CITY OF WICHITA

Re: **BZA2001-00069: An administrative adjustment to reduce parking requirements.**

Legal Description: Lots 91, 93, 95, & 97 on Douglas Ave., Hyde's Addition, Wichita, Sedgwick County, Kansas. Located at the southeast corner of Douglas and Ida (1109 E. Douglas).

PROPOSED RESTAURANT "THE ANCHOR"
1109 EAST DOUGLAS AVENUE
WICHITA, KANSAS 67211

A SITE PLAN
1" = 10'-0"

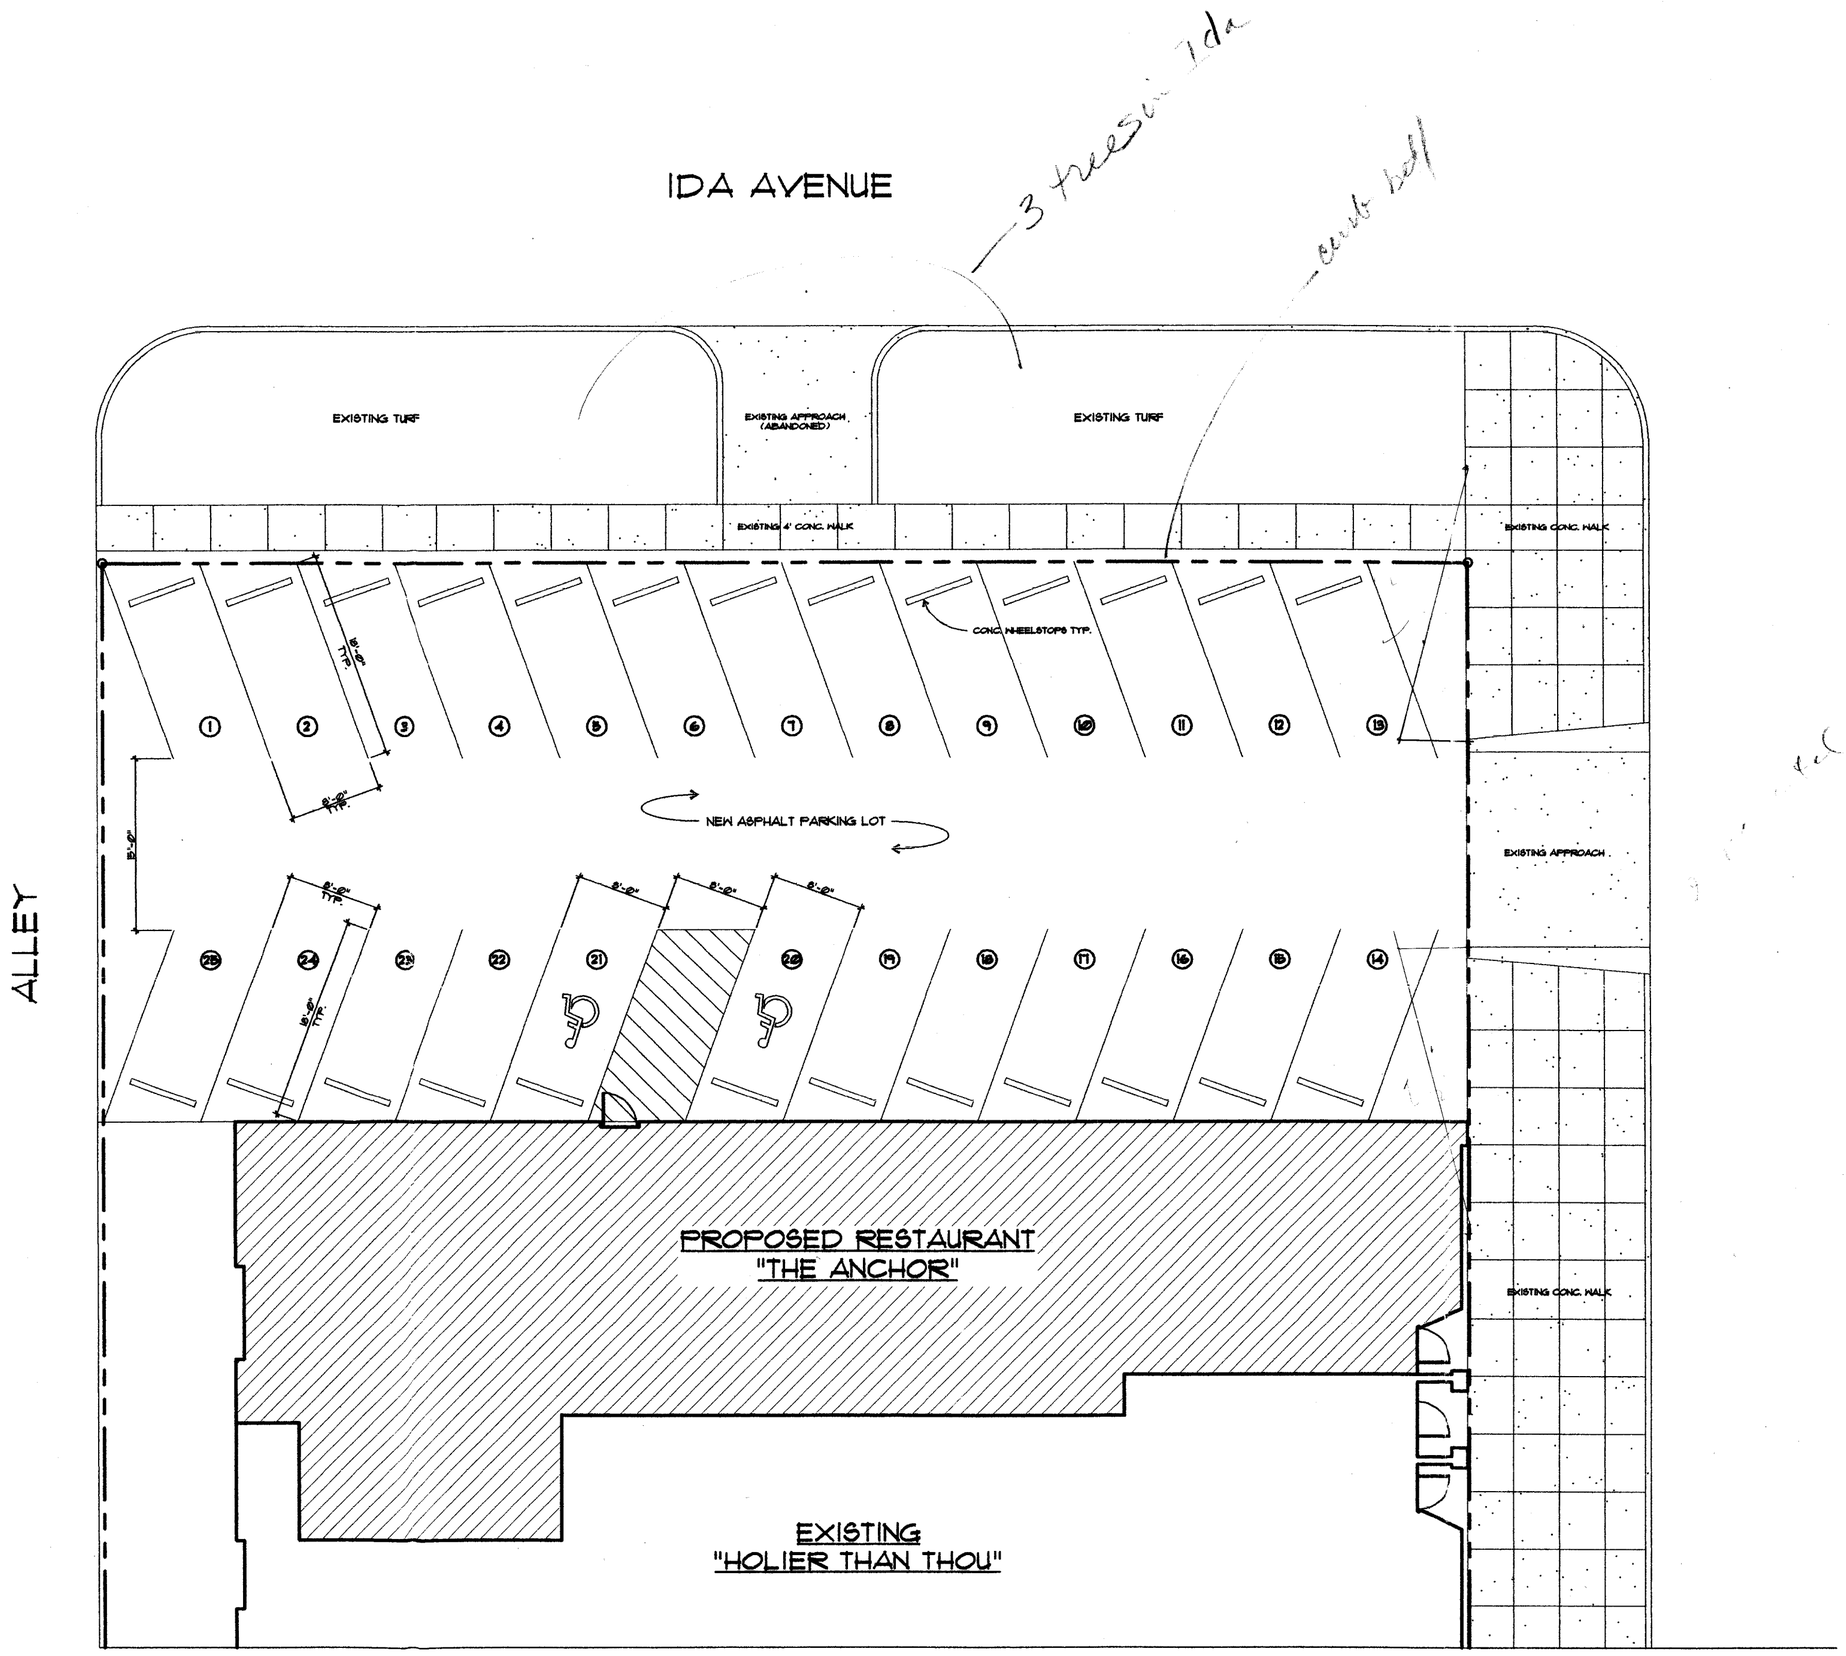
We have reviewed your request for an Administrative Adjustment to reduce parking requirements from 31 to 25 spaces for the aforementioned property. You state in your application that you propose to remodel the existing building for use as a restaurant. In reviewing the site plan, we find that all available land, even land that should be reserved to meet the requirements of the landscape ordinance, has been dedicated to parking, and only 25 spaces can be provided on site.

Since sufficient land is not being reserved to meet the requirements of the landscape ordinance, a waiver of landscape requirements will be needed. The conditions of approval indicate the minimum landscaping requirements for the site, and you are encouraged to contact Donna Goltry in the MAPD for assistance with getting your landscape plan and waiver of landscape requirements approved.

3) At a minimum, the following landscaping shall be provided:
   a) Two shade trees within "cut-outs" of the sidewalk, with one tree on each side of the parking lot drive to Douglas. Alternatively, the two shade trees may be located on the subject property north of the parking area, but this method is not preferred.
   b) Parking lot screening shrubs along the north property line.
   c) Three shade trees located west of the sidewalk along the Ida frontage.

1) The site shall be developed in general conformance with the approved site plan.

2) The parking area shall be paved and marked in accordance with the site plan.
